# **REPRESENTATION ON FLOOD RISK, GROUNDWATER AND HYDROLOGICAL IMPACTS**

**Planning Application:** Home Farm, Warminster

**Application Reference:** PL/2026/02717

### Aerial View Home Farm: Figure A3

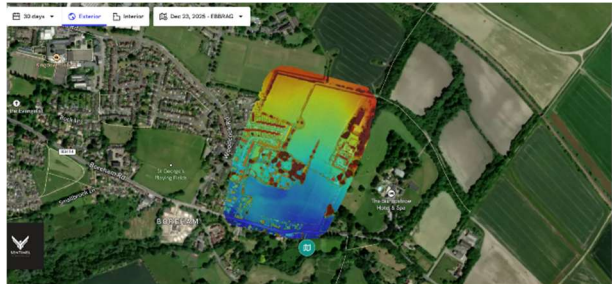
Photographs included within Appendix A record recent flooding on Boreham Road at the proposed site access (Appendix A, Figure A1) and across the adjoining field immediately south of Boreham Road (Appendix A, Figure A2) directly opposite the proposed attenuation basin. The accompanying drone imagery (Appendix A, Figure A3) further demonstrates that the southern part of the site, where the attenuation basin is proposed, occupies the natural low point within the landscape and remained inundated for a prolonged period following recent winter flooding.

- Drone photograph showing prolonged inundation of the southern part of the application site.
- Date: December 2025
